June 18, 1997

SUBJECT: Work Planning and Conduct of Operations at the Hanford N Basin

MEMORANDUM
FOR: G. W. Cunningham, Technical Director
COPIES: Board Members
FROM: J. W. Troan
SUBJECT: Review of Work Planning and Implementation at Bechtel Hanford Incorporated (BHI) Activities

Figure 1. N Basins, East End

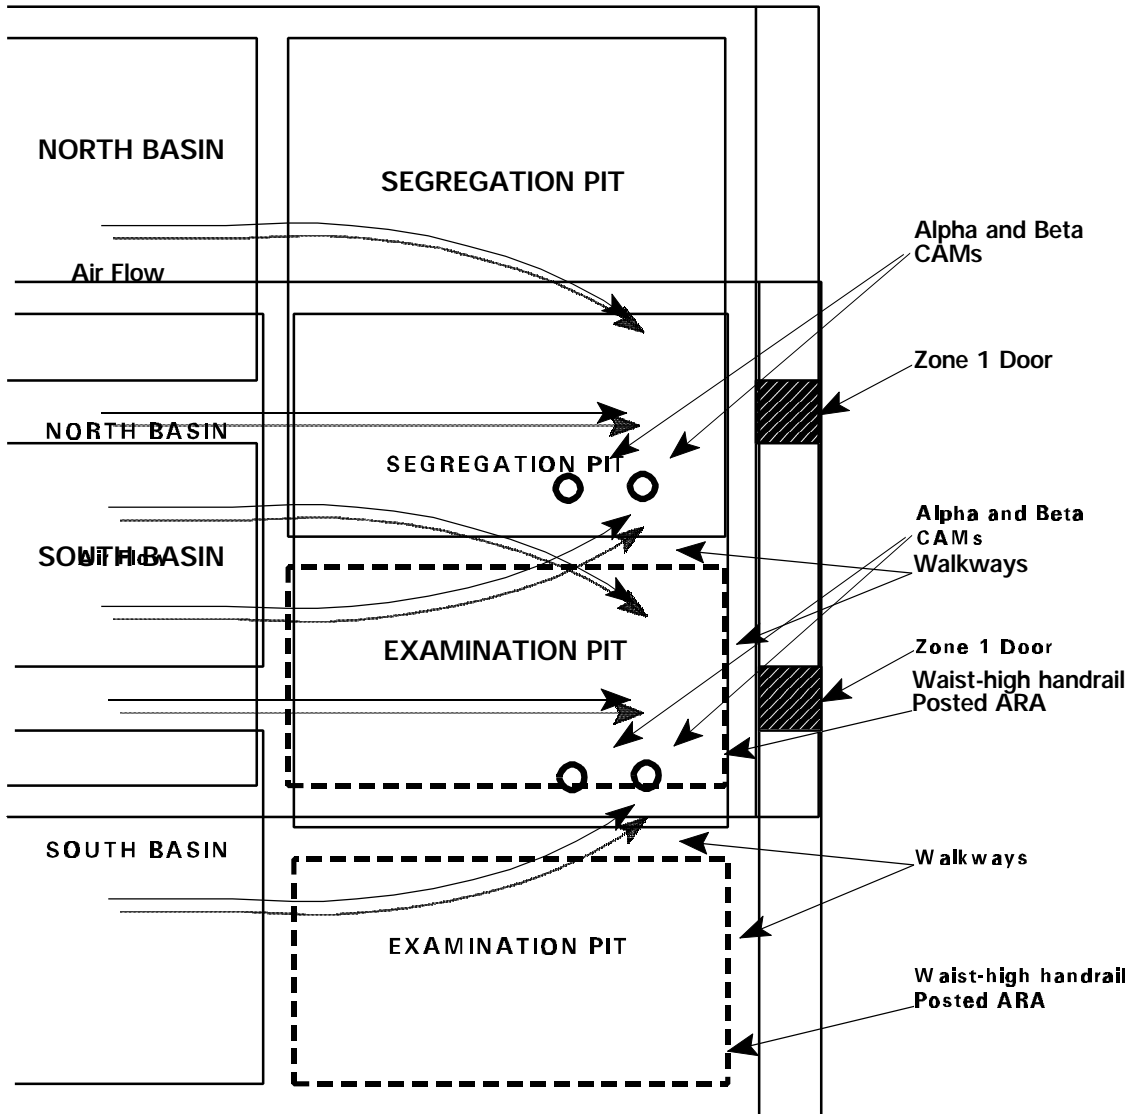
Airborne Radioactivity Postings. While touring the N Basin on March 27, 1997, the Board's staff observed airborne radioactivity area (ARA) postings on handrails that surrounded the Examination Pit (see  [Figure 1](#)). No physical barriers separated the air space of the posted airborne area from the unposted areas. The prejob briefing for the tour did not include mention of an ARA, nor was one identified on the radiological survey map. Walkways allowed access to basin areas that surrounded the posted area.

Upon further investigation, the Board's staff learned that N Basin management had stopped the cutting work (the near-miss event) requiring the postings, but that the radiological controls (radcon) organization had not authorized downposting of the area. Air samples taken after the work, which indicated potentially high airborne contamination levels, had not had sufficient time for the radon contribution to decay. Later, the radcon organization confirmed the presence of radon and removed the ARA postings.
